**PUR-1270  
ADDENDUM NO. 4  
INVITATION TO BID**

**CONOCOCHEAGUE TREATMENT PLANT ENR UPGRADE**

**DATE: Thursday, May 19, 2016**

**ENLARGED PUMP AND PIPING DETAIL**

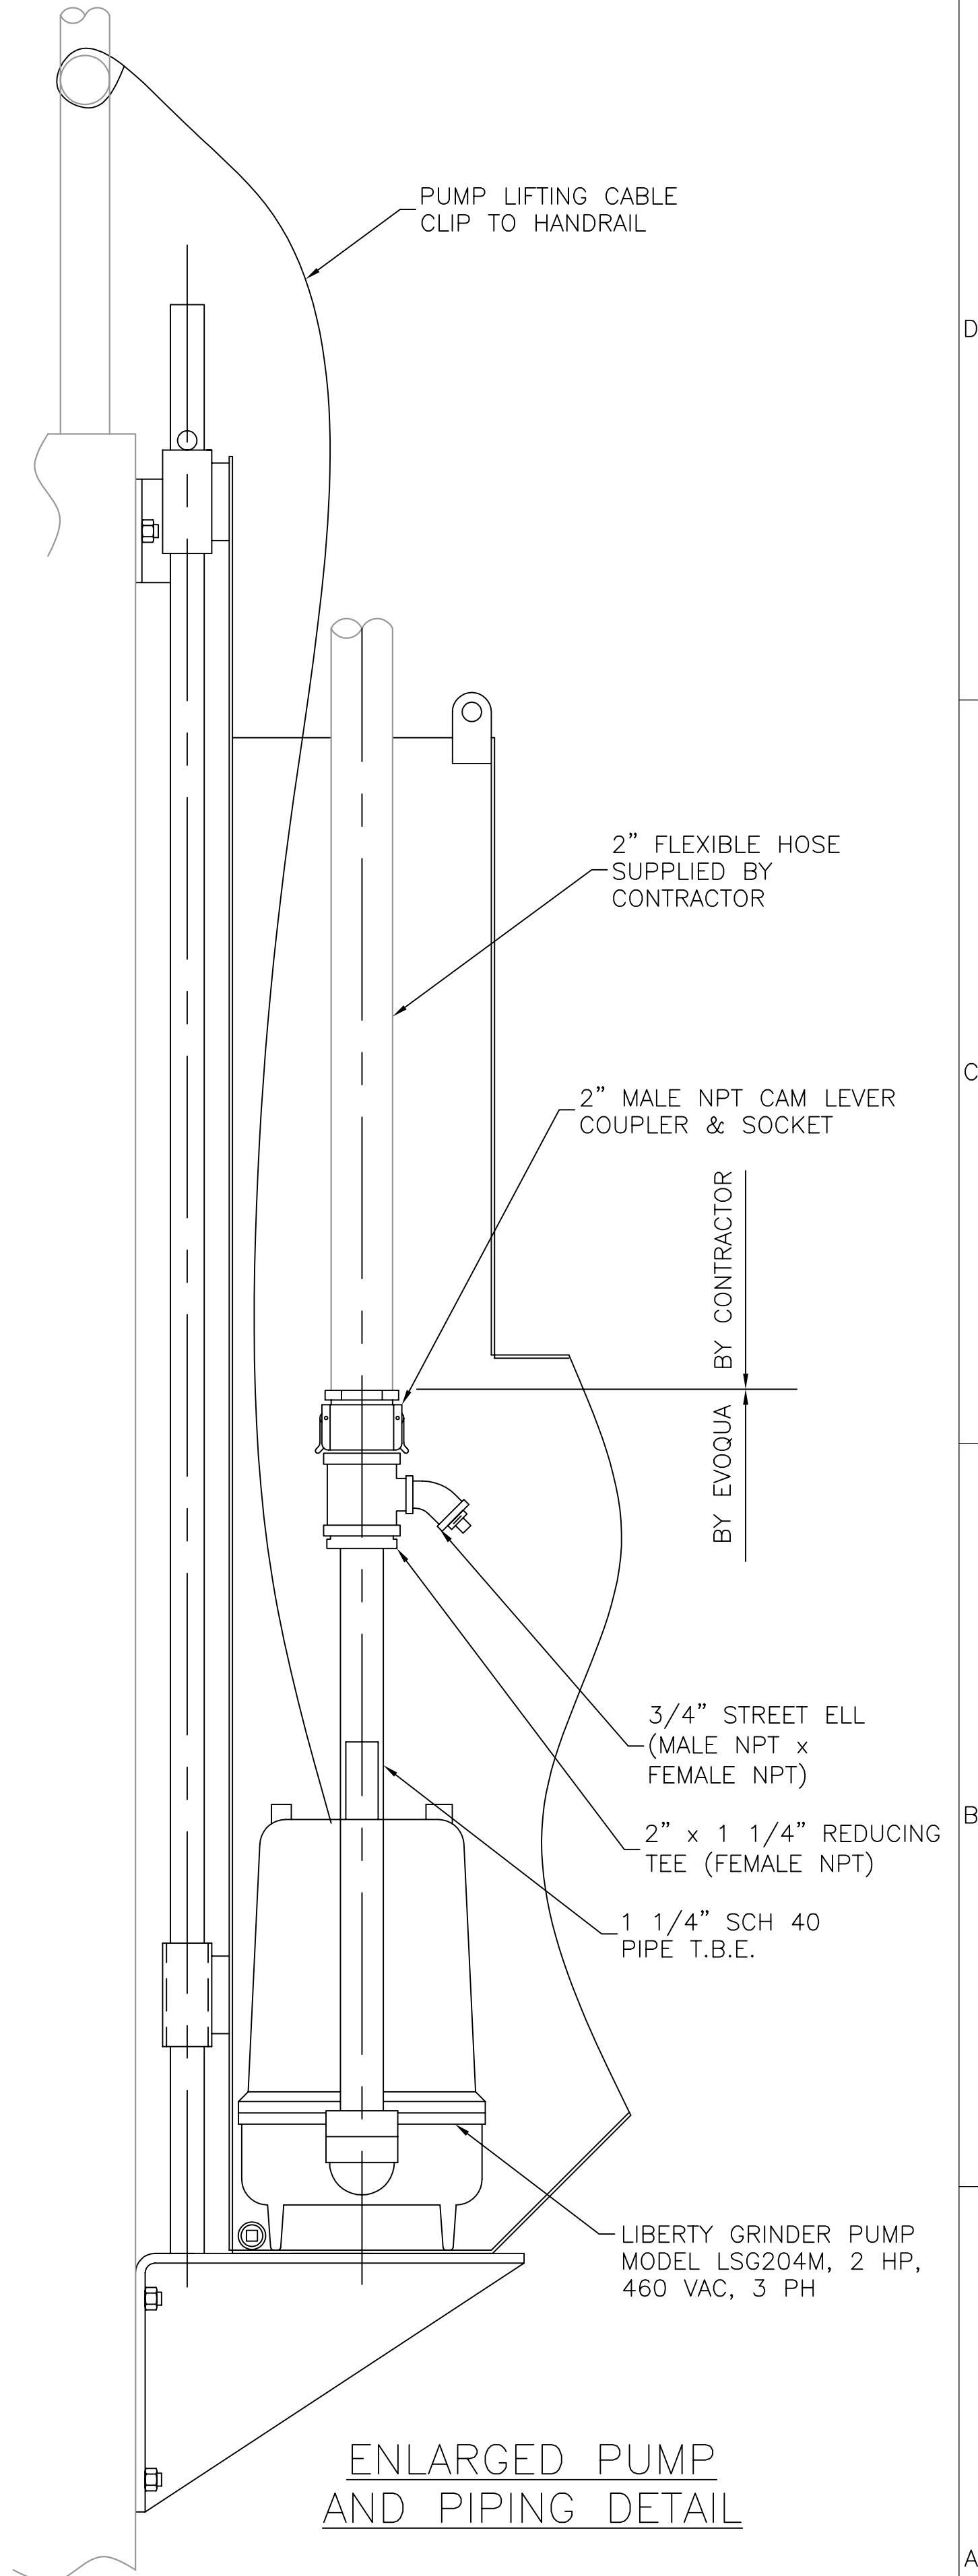
**ITEM NO. 54:** *Inquiry:* In Appendix A on Evoqua’s scope are (3) Surface Waste Pumps (P-310, P-320, P-330). I assume these are the “Surface Wasting Units” called out on section C on drawing PM-20. Please provide mounting details as the “depiction” on section C is not descriptive enough to discern what is required.

*Response:* The surface waste pump is included as part of the surface waste unit. The shop drawing provided by Evoqua for the Winebrenner project has been attached to this addendum for reference and bidding purposes only (drawing 45147-104). Approved shop drawings will be provided to the winning Contractor as they become available.
